A RESOLUTION AUTHORIZING THE EXECUTION OF AN AGREEMENT WITH KINGS CONTRACTING, INC. FOR THE REPAIR OF THE ROOF OF VILLAGE PROPERTY AT 120 ALGONQUIN ROAD

To: Trustee Zubak
From: Robert Kosin
cc: Board of Trustees, Village President
Date: September 22, 2017
Re: Fire Station Roof Repair

**RE: Fire Station #2
Barrington Hills, IL**

PROJECT: Village of Barrington Hills Fire Station #2			JOB NO.: 14001
ROOF AREA: North Roof	ROOF AGE: 20 years	BLDG TYPE: Masonry	ROOF SLOPE: 5:12
EVALUATION BY: Robert Heideman and William Richardson on April 11, 2014

ROOF SKETCH

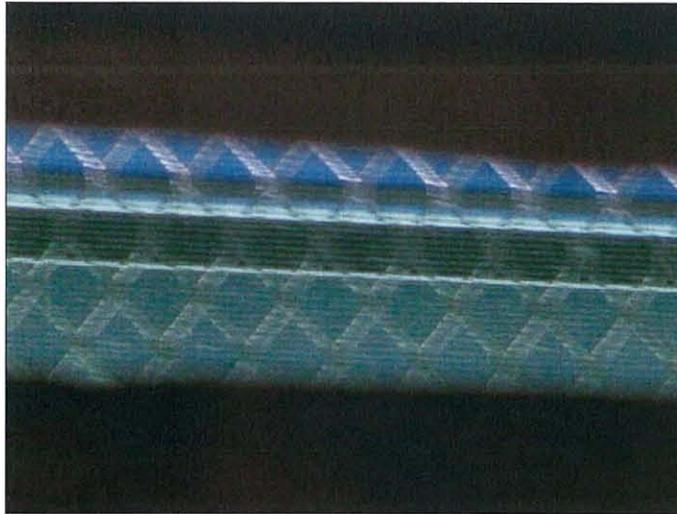
It was reported that water infiltration occurred at the north end of the apparatus room in February 2011. Evidence of this leak is visible at a drywall joint in the ceiling. The location of the damaged drywall coincides with the location of a functioning gable vent in the attic above. A second leak was reported in the apparatus room due east from the above leak. Its size was much smaller and is located in the vicinity of a dormer. The specific circumstances about the occurrence of this leak were not known. A third leak was reported in an electronics room under the newly installed shingles. The leak is located near the northwest corner of the area.

The damage at the north perimeter of the apparatus room is located in the vicinity of a gable vent as mentioned above. The damage was noticed shortly after the blizzard that the area experienced in February 2011. The blizzard brought with it near record-breaking snow accumulations and extremely high winds. Photo #1 shows the gable vent from the interior. To keep pests out, approximately one inch screening was used over the gable opening. An inspection of the roofing at this area showed no defects. It is my opinion that the large quantities of wind driven snow experienced during that storm created the variables necessary for snow to enter the attic through the gable vent and accumulate in the attic. To prevent future occurrences, the Village could consider installing screen with smaller openings that in effect will filter the snow that tries to enter into the attic through the gable. This will have little effect on the function of the gable vent.

The second leak in the apparatus room is located in the vicinity of the northeast dormer. It is possible that this is also related to the snow accumulation that occurred during the blizzard. There were minor sealant defects found on the window that will require repair. If the leak occurs again in the future, the conditions necessary to make this leak occur should be noted to ensure that an effective repair is made.

1. Consider installing smaller screening on gable vent. (Photo #1)
2. Seal open caulking. (Photo #4)
3. Re-secure heat cable mounts. (Photo #7)

PROJECT: VILLAGE OF BARRINGTON HILLS FIRE STATION #2 120 S. ALGONQUIN RD.		DRAWING TITLE: ROOF SKETCH	
PROJECT #: 14001	DATE: 04/14	SCALE: N.T.S.	DETAIL #: RS - 1

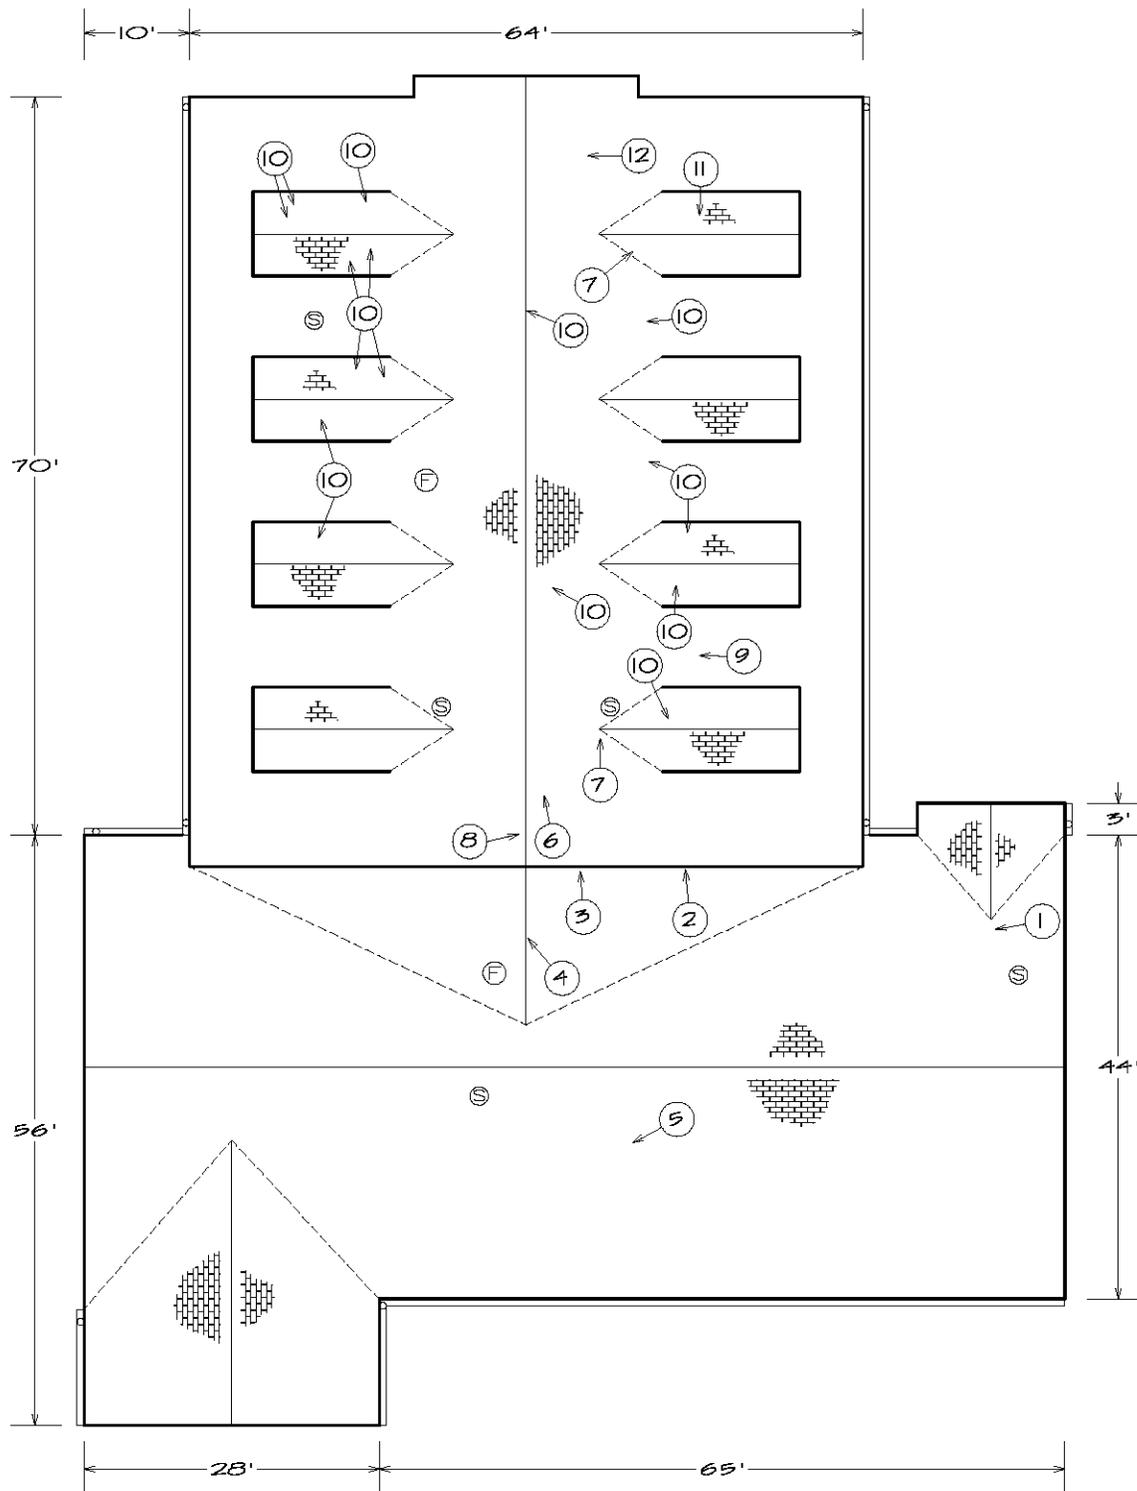
1. Replace split shingles (Photos #7 & 9)
2. Replace deteriorated ridge caps (Photo #8)
3. Re-nail fastener, seal shingle (Photo #10)
4. Remove shingles, re-nail plywood, install new shingles (Photo #12)

1. Repair open seams on low slope valley east side (Photos #2 & 4)
2. Remove backed out fastener, install new fastener (Photo #3)

The Fire Station #2 has two roof sections. An older shingle roof to the north which no leaks were reported on but there are several backed out fasteners and split shingles. Recommended repairs should allow this roof to remain serviceable for two more years.

The second section is the south which is a newer shingle section that is performing satisfactorily at this time. The low slope valley between the two sections has some open seams that should be addressed. There are heat cables on the west side that are loose and should be re-attached.
